NORTHERN BEACHES LOCAL PLANNING PANEL

WEDNESDAY 16 MARCH 2022

ITEM 4.1	DA2021/1805 - 4 ALEXANDER STREET, COLLAROY - DEMOLITION WORKS AND CONSTRUCTION OF A SENIORS HOUSING DEVELOPMENT
AUTHORISING MANAGER	Steve Findlay
TRIM FILE REF	2022/140039
ATTACHMENTS	1 Assessment Report 2 Site Plan and Elevations 3 Clause 4.6 - Clause 40(3) 4 Clause 4.6 - Clause 40(4)(b) 5 Design and Sustainability Advisory Panel Report

Application Number:	DA2021/1805
Responsible Officer:	Adam Mitchell
Land to be developed (Address):	Lot A DP 379308, 4 Alexander Street COLLAROY NSW 2097
Proposed Development:	Demolition works and construction of a seniors housing development
Zoning:	Warringah LEP2011 - Land zoned R2 Low Density Residential
Development Permissible:	Yes, under State Environmental Planning Policy (Housing for Seniors or People with a Disability) 2004
Existing Use Rights:	No
Consent Authority:	Northern Beaches Council
Delegation Level:	NBLPP
Land and Environment Court Action:	Yes
Owner:	East Coast Property Development Pty Limited
Applicant:	East Coast Property Development Pty Limited
Application Lodged:	07/10/2021
Integrated Development:	No
Designated Development:	No
State Reporting Category:	Res

Figure 1 - Plan extract showing the 3 storey building height as viewed from the east

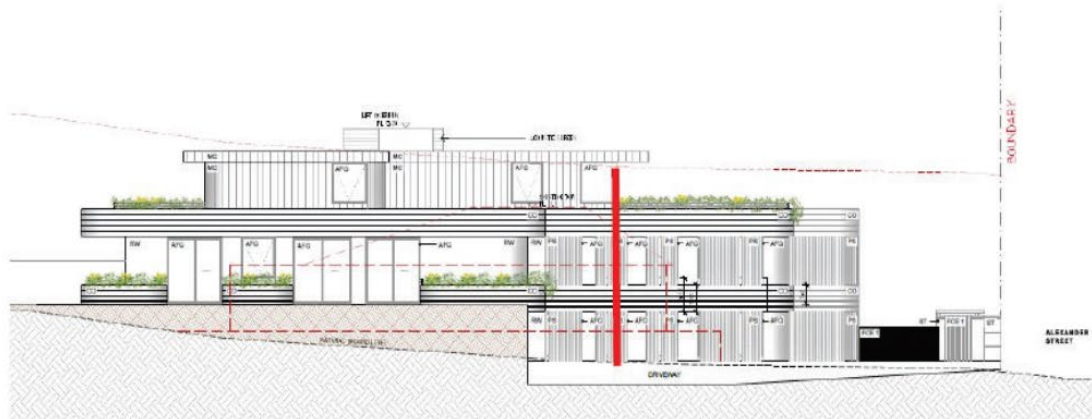
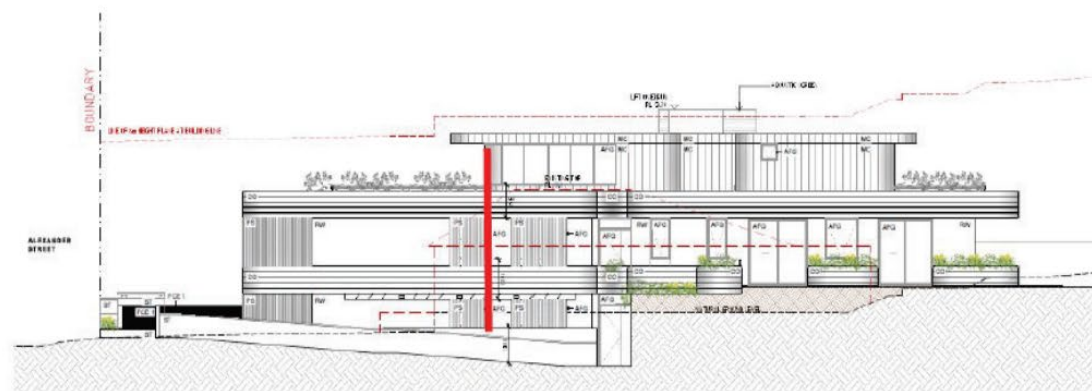
Below are two figures taken from the applicant's Clause 4.6 variation request which show (with red bolded line) the portion of buildings adjacent to a boundary that are more than two storeys in height:

The topmost floor of the proposed development is the offending portion of the building with respect to cl.40(4)(b). That floor is stepped in from the outer edges of the floor below and finished with a different facade material to visually break up the building. The extent of areas where the building is perceived as three (3) storeys when adjacent to a boundary is relatively minor compared to the totality of the building. It is concurred with that there is no meaningful planning reason to ensure compliance with the control is maintained as the building is well designed and set off the boundaries significantly greater than what is required.
